Errata

SLG46811

CE-GP-008

3.1 Incorrect 64 mV Hysteresis Operation while Using MS ACMP in Regular ACMP Mode

Figure 1: Testing Design

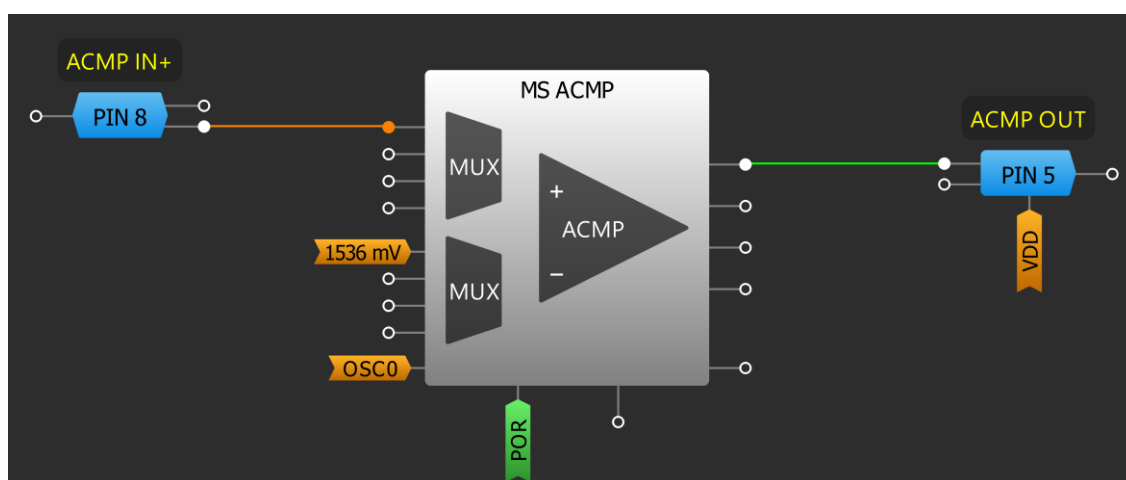
If using MS ACMP in Regular ACMP mode with 64 mV hysteresis, MS ACMP output could be glitching when MS ACMP positive input (IN+) close to the negative input (IN-). It can happen when $V_{DD} = 4.0$ V or higher and $V_{ref} = 1344$ mV or higher.

1. Use the deglitch filter connected to the MS ACMP output.
2. Decrease the reference (below 1344 mV) at IN^- and add the IN^+ gain to keep the needed threshold.
3. Use MS ACMP in multichannel mode.

Figure 2: ACMP Output during Glitching

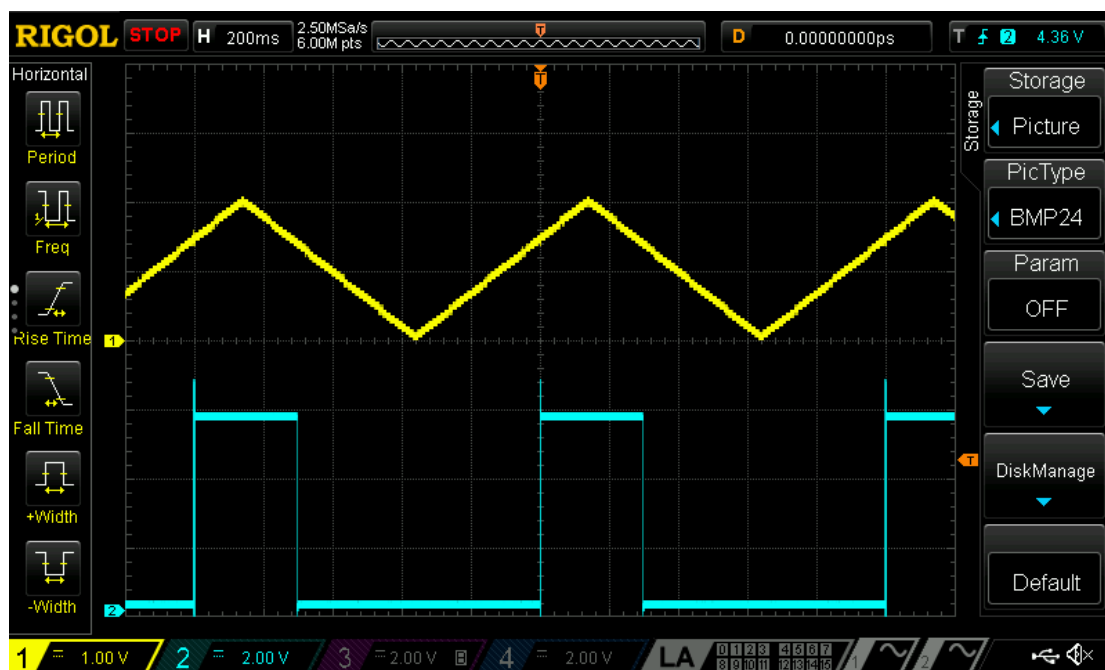
1. Waveform at $V_{ref} = 1536$ mV, hysteresis is equal to 64 mV.

Figure 3: Zoomed ACMP Output during Glitching

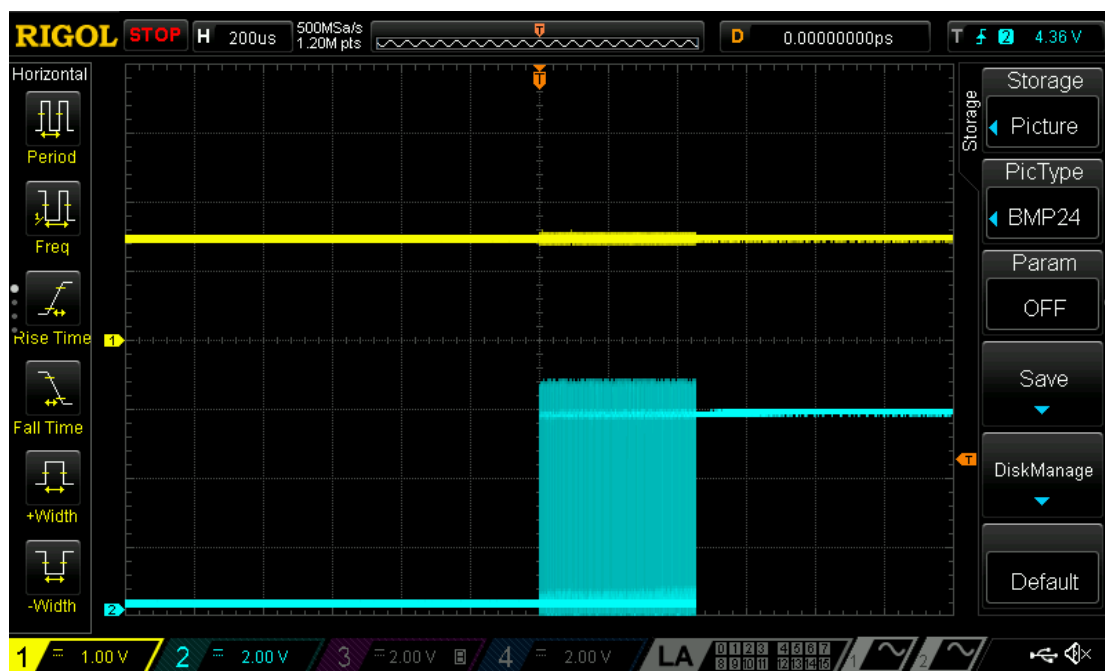
2. Waveform at $V_{ref} = 1536 \text{ mV}$, hysteresis is equal to 64 mV (zoomed rising edge).
